DUKE POWER COMPANY

Re: McGuire Nuclear Station
Docket Nos. 50-369, 50-370
Outstanding Information Responses

DUKE POWER COMPANY
Request For Relief From
Inservice Inspection Requirement

Reactor Coolant Loop Piping
Attachment Weld NC2FW 83-H47

LAST WELD NO.		BILL OF MATERIAL		CONDITION	
47		DUKE POWER COMPANY		LAST NO.	
		McGUIRE NUCLEAR STATION		11A	
NUCLEAR SAFETY RELATED		TEC. NO.		BUILDING	
		11A		11A	
PREPARED BY		SYMBOL		DRAWING NO.	
2001		N/C		2001	
APPROVED BY		CLASS		NO. NO.	
A. M. E. 500		A		11A	
		CLASS		REV.	
		A		7

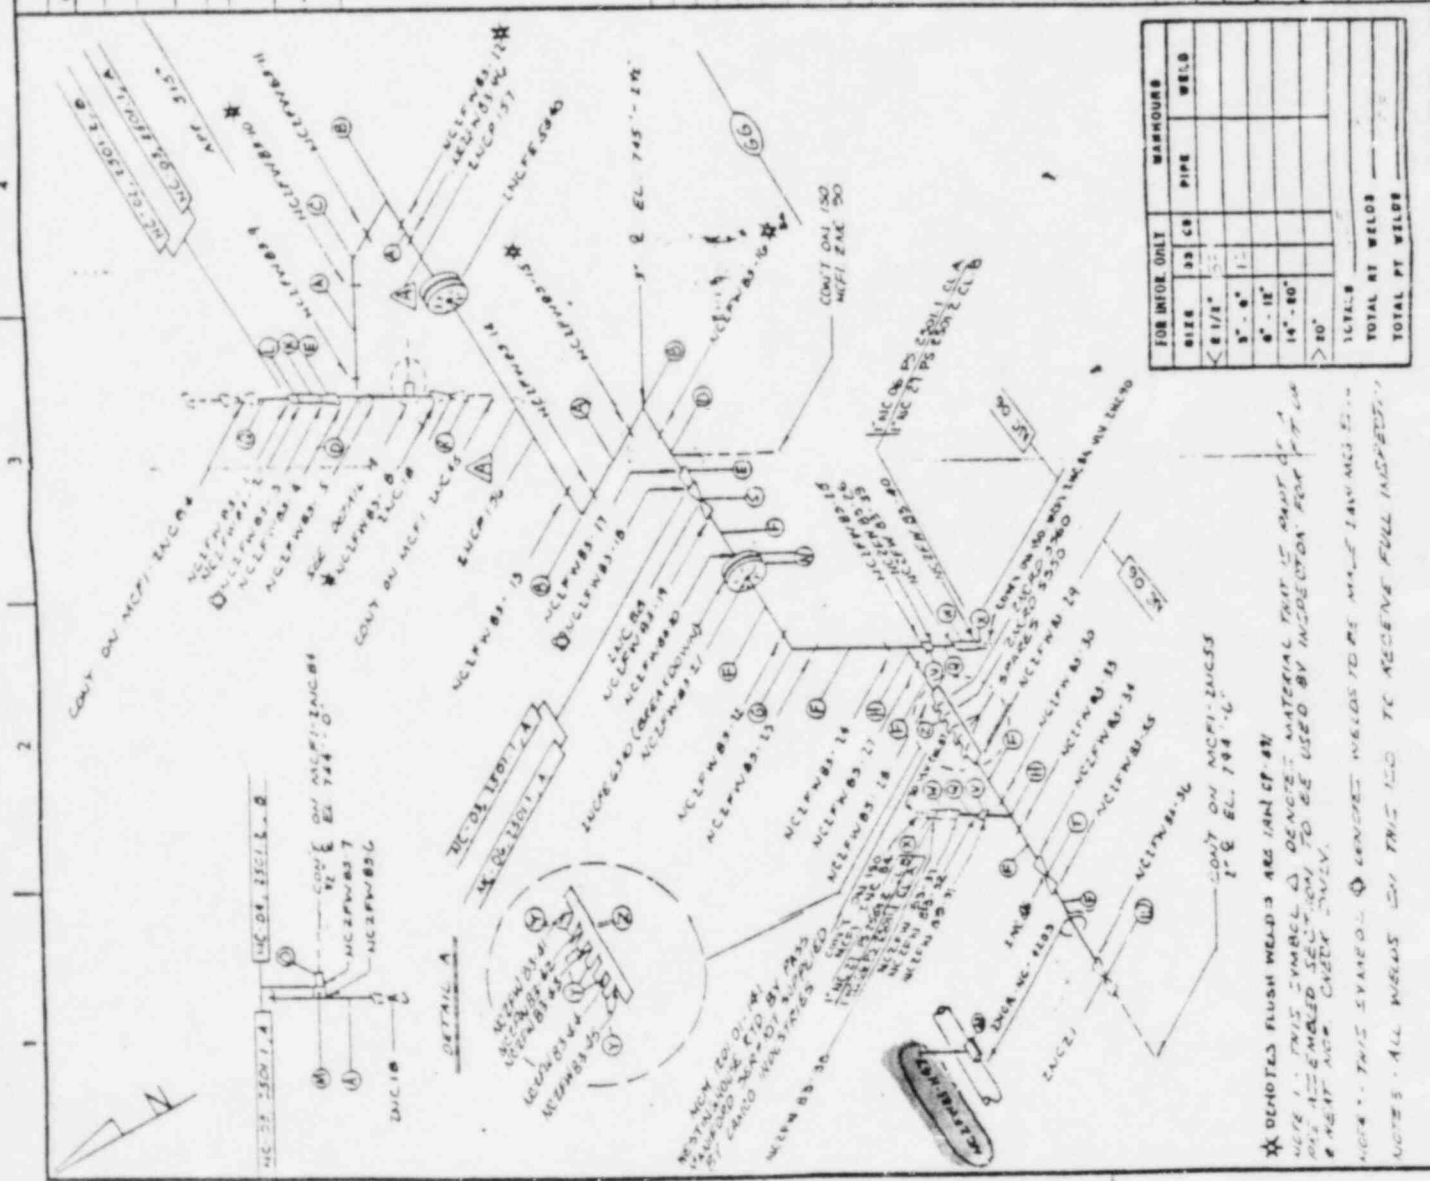
Table IWB-2600 Item No. B4.9 requires volumetric examination for integrally welded supports. Ultrasonic examination is impractical due to configuration, and radiography cannot be performed for inservice inspection due to accessibility. See Attachment 1 & 2

Estimate of preservice examination performed - 0%
Original fabrication examination - dye penetrant
Measures which would be required to make the area accessible - Removal
of Hanger 2MCR-NC-4203

Removal of hanger would not give a meaningful volumetric examination. Construction examination provided adequate assurance of component reliability.

IV. Alternate Examination: None Available

V. Implementation Schedule: No inspection due to accessibility.
